PHOENIX CONTACT Deutschland GmbH

Marketing Device Connection Technology Heiko Steinkamp August 7, 2014

Change of the outer contour and surface structure – A02-12020 Please forward this information to your electrotechnical departments!

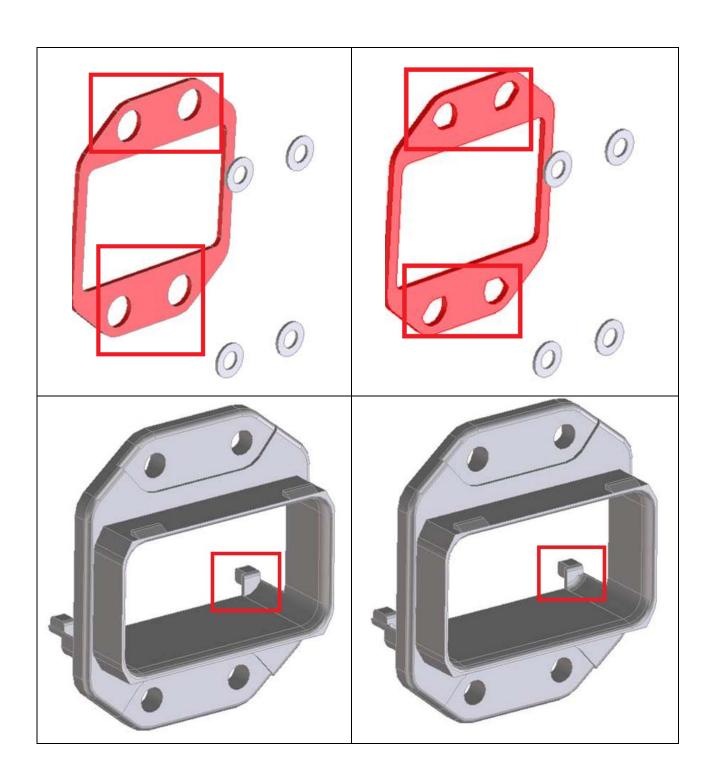
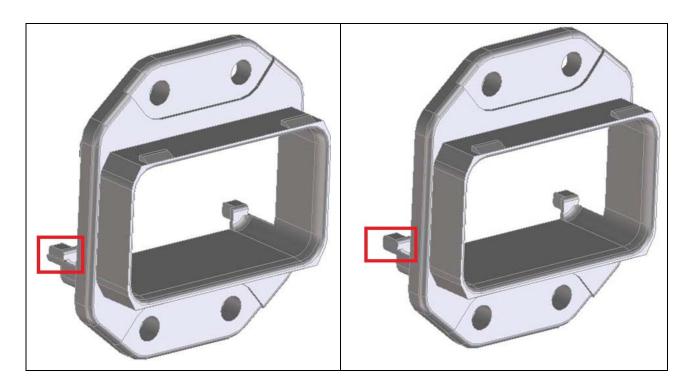
Different optimizations were implemented at the outer contour of the panel mounting frame as part of product improvements. In the area of the screw holes, the contour was adjusted to improve the sealing. As a result, the contour of the sealing changed as well. Furthermore, the contours of the PCB installation edge were adjusted. In addition, the surface structure changes due to a change of the supplier. The surface is no longer matt, but shiny. The electrical and other technical features are not affected by this change.

The existing stock can still be used. The new version has already been delivered since calendar week 30/2014.
